Access Compliance Report

Public Rights-of-Way

Intersection ID: 13715	Main Street: E_MOREHEAD_ST	Cross Street: MYRTLE_AV	Location: S
ADA ID: 9DF7F0D8296E	Ramp Type: Perp	Initial Pass/Fail: Fail	Overall Compliance: No
			Severity Score: 1.25

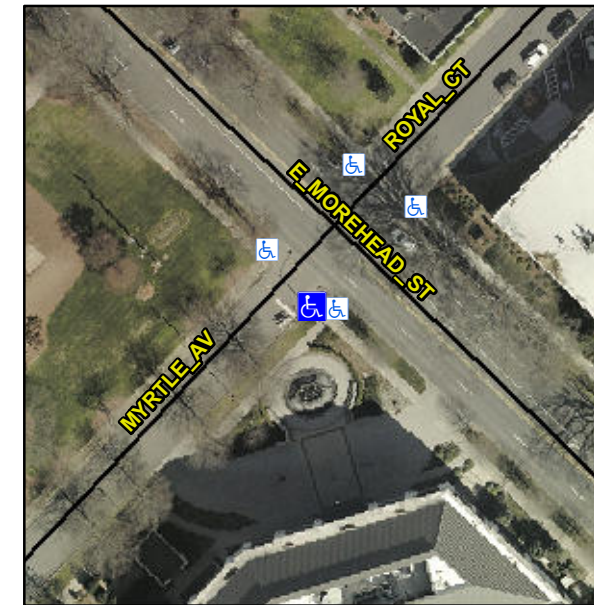
Not Found, R304.5.3

Compliance	Description	Data	Compliance	Description	Data
N/A	Ramp Length (in)	101.0	Yes	Ramp Slope (%)	5.7
Yes	Ramp Width (in)	69.0	No	Ramp XSlope (%)	2.8
N/A	Flare Type LT	N/A	N/A	Flare Type RT	N/A
N/A	Flare Slope LT (%)	N/A	N/A	Flare Slope RT (%)	N/A
N/A	Flare Traversable LT?	N/A	N/A	Flare Traversable RT?	N/A
N/A	Landing Length (in)	N/A	N/A	DWS Provided?	N/A
N/A	Landing Width (in)	N/A	N/A	DWS Contrast?	N/A
N/A	Landing Slope (%)	N/A	N/A	DWS Length (in)	N/A
N/A	Landing X Slope (%)	N/A	N/A	DWS Full Width?	N/A
N/A	Landing Curb? (Y/N)	N/A	N/A	DWS Offset (in)	N/A
N/A	Shared Landing?	N/A			
N/A	Gutter Ponding?	N/A	N/A	Gutter Slope (%)	N/A
N/A	Gutter Lip Ht (in)	N/A	N/A	Gutter X Slope (%)	N/A
N/A	Painted X Walk1?	No	N/A	Painted X Walk2?	N/A
	X Walk 1 Direction	To NW		X Walk 2 Direction	N/A
N/A	X Walk 1 Width (in)	N/A	N/A	X Walk 2 Width (in)	N/A
	X Walk 1 Slope (%)	5.5		X Walk 2 Slope (%)	N/A
	X Walk 1 X Slope (%)	2.0		X Walk 2 X Slope (%)	N/A

Remove & Replace Entire Ramp.
